Subject: Beaver Valley Power Station, Unit No. 1 and No. 2
BV-1 Docket No. 50-334, License No. DPR-66
BV-2 Docket No. 50-412, License No. NPF-73
NRC Bulletin 2003-02
BV-2 Lower Head Inspection 60-Day Report

Evaluation Report for 2R10
Inspection
of
Beaver Valley Unit 2
RPV Lower Head Penetrations

Responses to NRC Teleconference Questions

Figure 1: Locations of residue observed in or near penetration annulus.

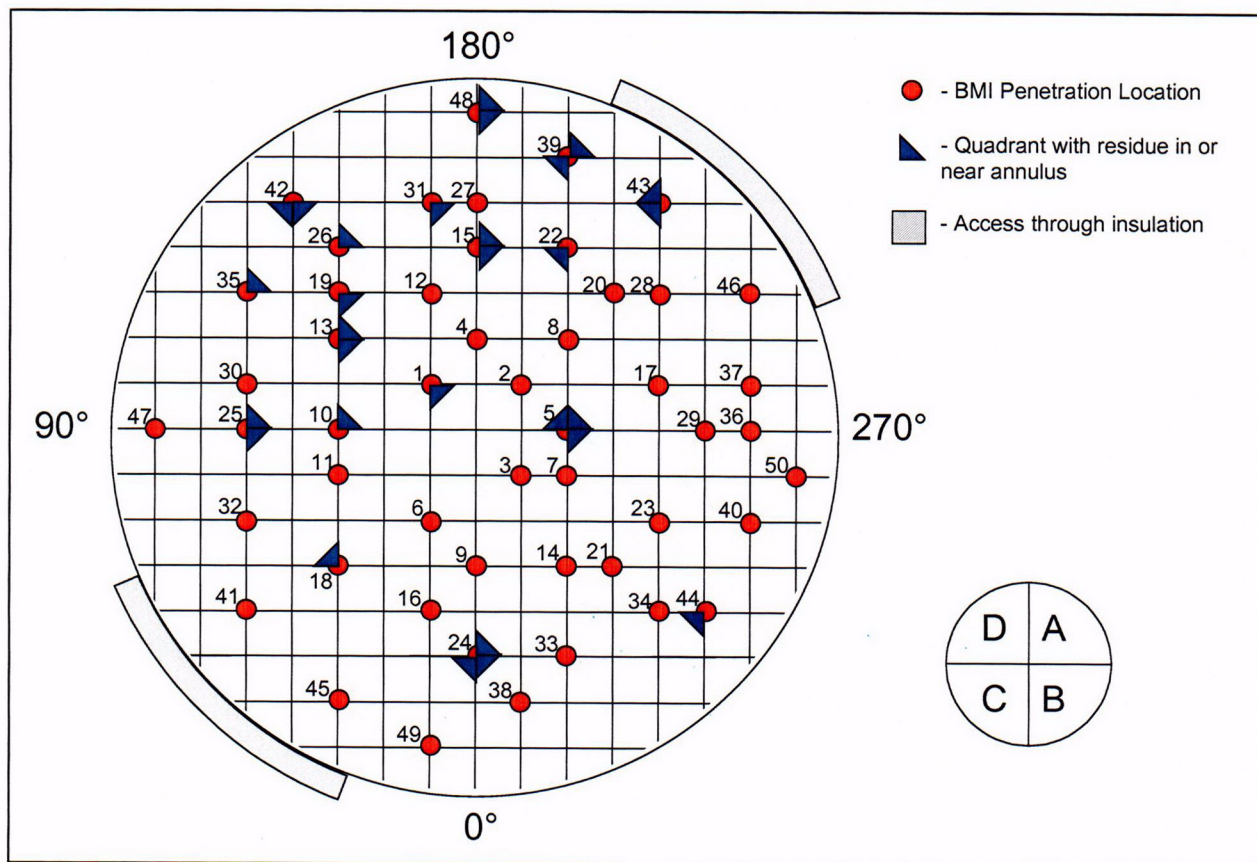
c. Is there any particular location of the penetration where the deposit is more predominant (i.e., the hill side of the vessel....). A picture depicting the BMI tubes and the locations of the deposits would be beneficial.

As shown in Figure 1 of this response, residue was observed in or near the annulus on the uphill, downhill, and sidehill orientations. The residue observed on the boss around many penetrations is randomly oriented in all directions. As shown in Figure 2, similar residue is observed on the vessel surface as well.

Figure 2: BVPS Unit 2 lower head observed during 2R10.

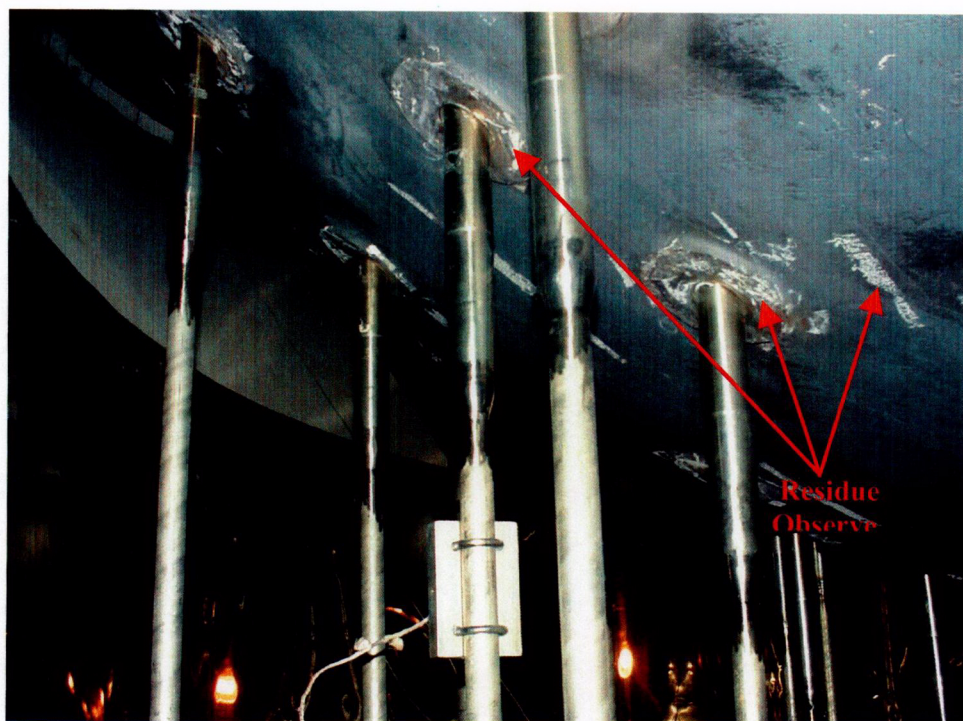
3. *Please discuss why the tape/paint would be placed around some nozzles but not all.*

There is evidence of residue on or around virtually every nozzle as shown in Figure 2. However, only 18 penetrations showed residue in or near the annulus and were thus called out for further evaluation during the visual exam.

Figure 8: BVPS Unit 2 reactor vessel with Spraylat coating applied.

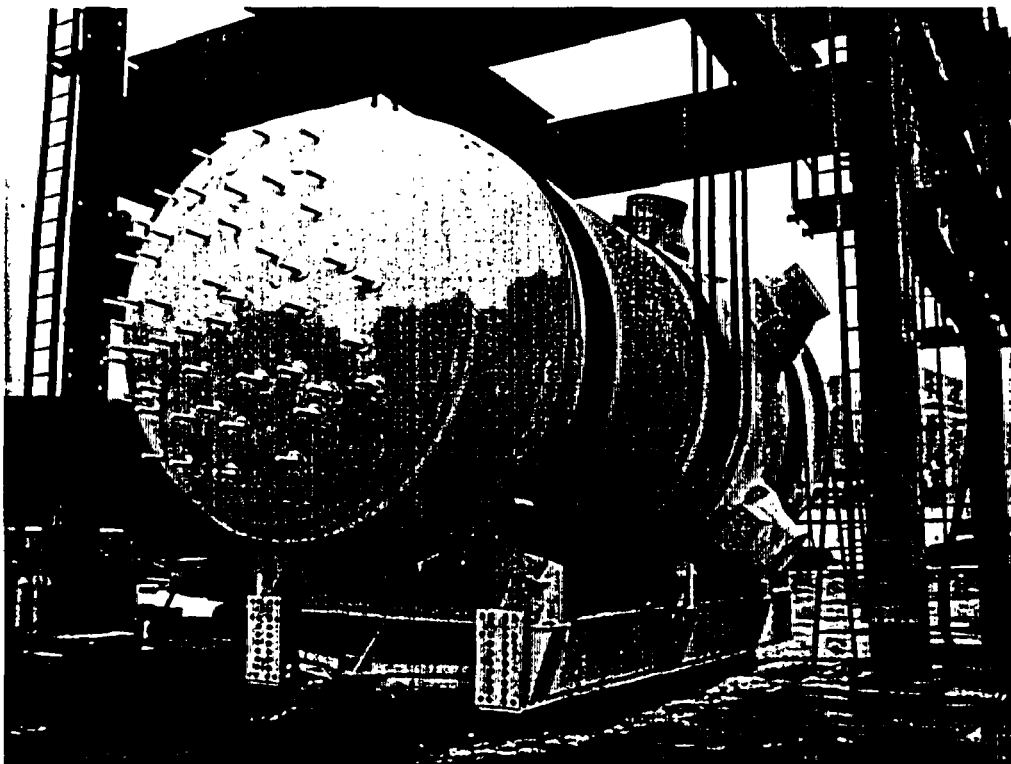
4. *Discuss whether there are any photographs of the lower head since fabrication that would support your root cause.*

3. *Discuss what you have learned about the tape/paint from review of original construction records. Were any previously taken photographs of the lower vessel head available?*

Figure 8 shows the Unit 2 vessel with the Spraylat coating applied. Figures 10 and 12 show images of two other vessels in the packaged configuration, both fabricated by Combustion Engineering and of similar vintage. The method in which the vessel was packaged is clearly visible in each case.

The only picture obtained of the BVPS Unit 2 lower vessel head is shown in Figure 8. Figures 10 and 12 show two CE-fabricated vessels of similar vintage in their packaged configuration. Since installation, the BVPS Unit 2 lower head insulation had not been removed until 2R10. Thus, no previous pictures of the residue exist.

Figure 13: Streaking on Penetration 39 (a) and similar streaking on vessel surface and insulation uphill of Penetration 39 (b).

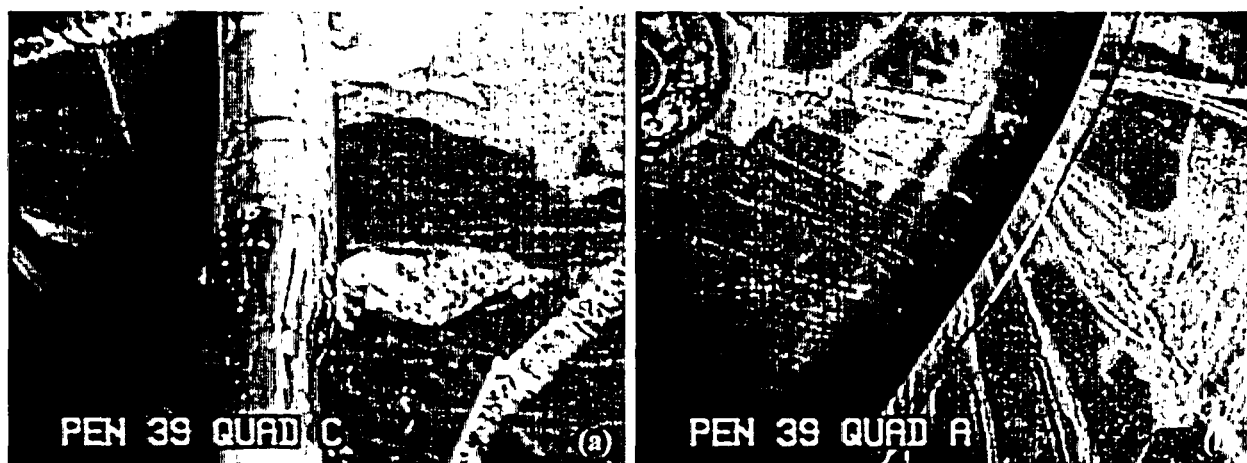
2. *Please discuss whether any "deposits" were found on the surface of the insulation facing the head. Please discuss how these "deposits" would appear both in the annulus and on the tube if the root cause was it was paint or tape placed on the head during the fabrication.*

7. *Penetration 39, quadrant C appears to have streaking down the instrumentation tube. Is this the case (or is it an artifact of the lighting angle)?*

In some locations, milky white streaking was observed on the surface of the insulation facing the head, presumed to be the result of previous reactor cavity seal leakage from above. The streaks were of no discernable thickness. The streaking observed is shown in Figure 13b.

The streaking on Penetration 39 appears milky white in color, has no discernable thickness, and is not visually characteristic of penetration leakage (Figure 13a). Inspection of the vessel surface uphill of Penetration 39 shows streaking on the side of the vessel and insulation panels as well (Figure 13b), leading to the conclusion that previous reactor cavity seal leakage likely ran down the side of the vessel and onto the surface of Penetration 39, leaving a thin milky white stain.
